Informal document GRSP-75-28
(75th GRSP, 27 – 31 May 2024
Agenda item 8)

CLEPA Answer to GRSP/2024/15

EQOP - WHIPLASH

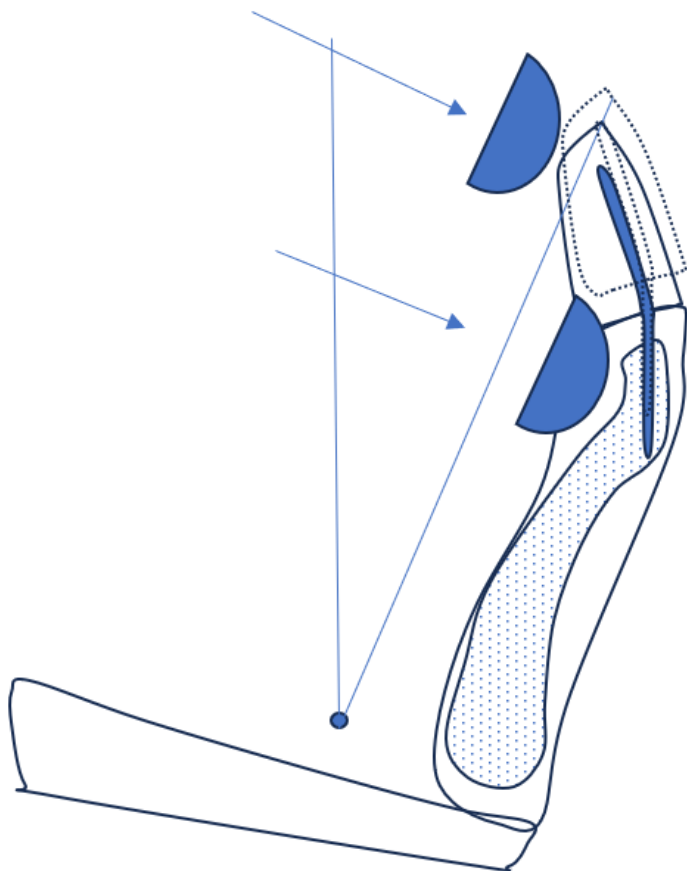
The occupant spine needs to keep its shape between the upper neck and the lower neck in rear impact in order to minimize whiplash associated disorders.

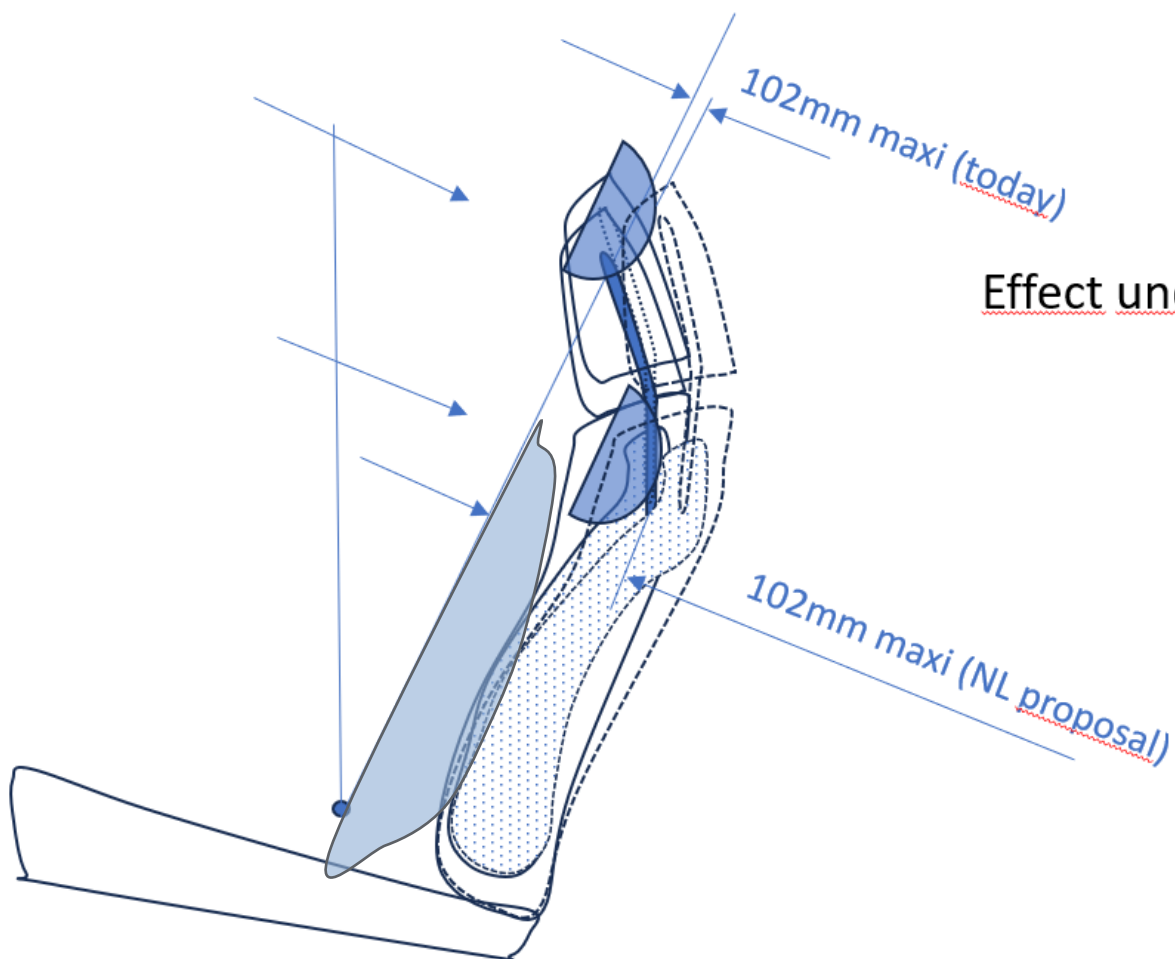
The NL proposes to use the backset retention test in any height over 540mm up and keeps the 102mm maximum displacement requirement of the sphere.

Effect under load of the sphere

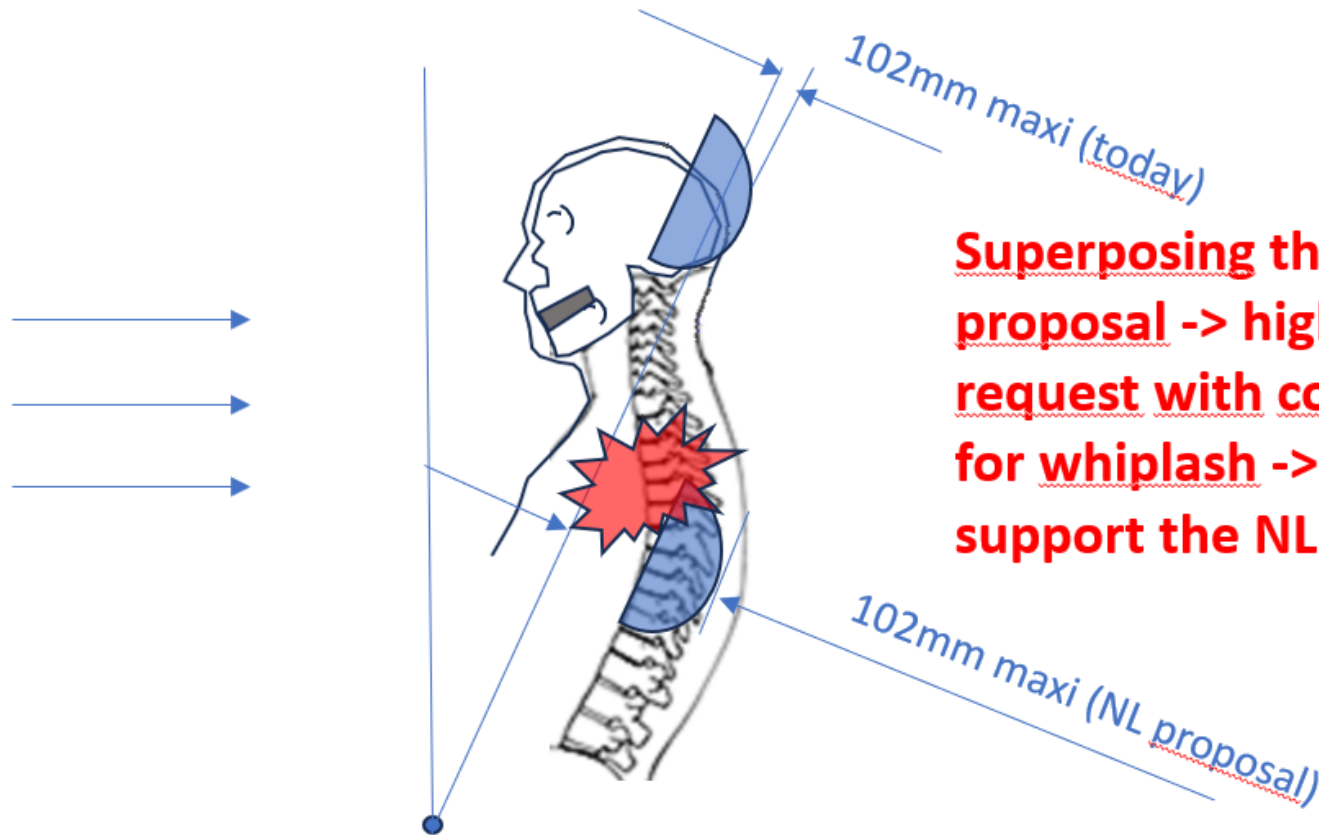
Superposing the need and the NL proposal -> high risk to answer to NL request with countermeasures NOK for whiplash -> CLEPA does not support the NL proposal
